FTI-STP1 v 1.0 Harness Bulletin: Immobilizer Wire

FTI-STP1 v 1.0 A/T Application Bulletin/Advisory

MODIFICATION REQUIRED FOR A/T APPLICATIONS, ONLY WITH v 1.0 HARNESS

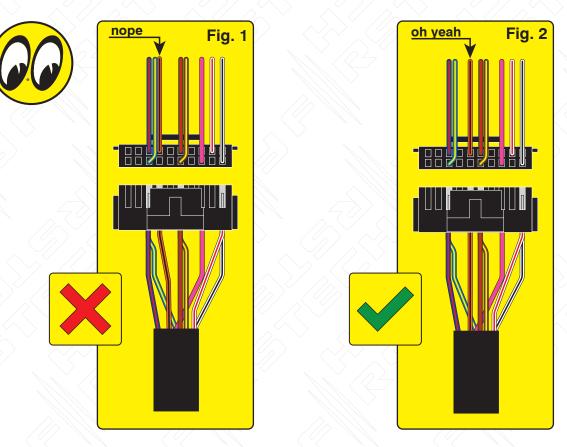
Overview: Production error in version 1.0 harnesses; The immobilizer wire (orange/black) is in pin position #4 instead of pin position #5. Although an effort to correct the issue was made, some quantity of harnesses did get shipped before the issue was spotted. We are advising to inspect the harness BLADE connector before attempting to install harness or program the module. This issue is not known to affect the version 2 harnesses, which require no modification.

Issue: Module fails to program correctly to vehicle, does not allow the vehicle to be remote started.

Correction: Step 1.) Locate the orange/black wire and confirm whether it is positioned as illustrated in Fig. 1 or Fig. 2. If the wire is as illustrated in Fig.1, proceed with Step 2 through 5 and complete the repair procedure outlined, if the wire is as illustrated in Fig. 2, correction is not necessary, proceed with harness installation and module programming.

- Step 2.) Using a pick, lightly depress the catch that secures the terminal in the housing then remove the wire and terminal from the housing.
- Step 3.) Using a fine tip razor or utility knfe, inseret the blade beneath the terminal catch and raise it slightly, so that it can be reused to secure the terminal when reinserted into the BLADE connector housing.
- Step 4.) Refer to Fig, 2 for correct position of the orange/black wire (next to brown/red) then reinsert the terminal, pressing lightly until the catch 'snaps' into place, securing the terminal in the connector housing.
- Step 5.) The repair is complete, proceed with installation and programming.

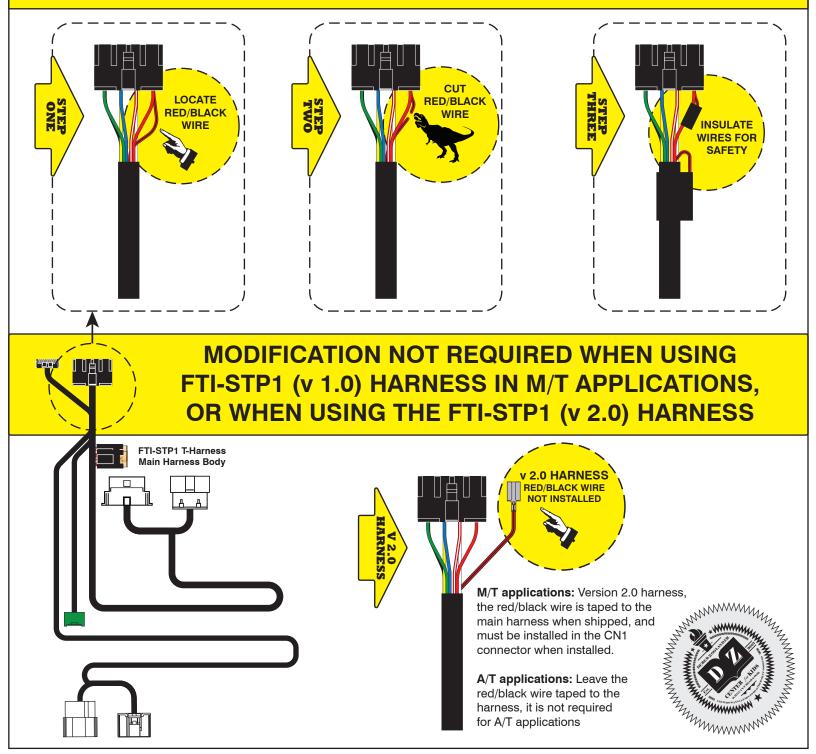
Overview: Early versions of the **FTI-STP1** harness require modification for **automatic transmission (AT)** applications, some of the product was able to be modified before release, but a small quantity was released without modification.

Issue: The FTI-STP1 T-harness has been designed to be compatible with A/T (automatic transmission) & M/T (manual transmission) applications, but due to an oversight in early production runs, the selection was defaulted to M/T mode.

Using a harness configured for an M/T application, in an A/T equipped vehicle, could result in vehicle module damage, it is advised that the harness be returned to A/T mode before installation in vehicles equipped with an automatic transmission.

Correction: Locate the **red/black** (+ Clutch) wire provided in the CN1 connector of the main harness assembly. Cut the **red/black** wire, either flush to the CN1 connector, or leaving enough wire exposed so that you can insulate and secure the ends of the wire that remain after cutting. Insulate each of the remaining ends of the **red/black** wire and secure to prevent any possibility of a short circuit. **If the red/black wire has already been disconnected, no further modification is required for A/T applications**
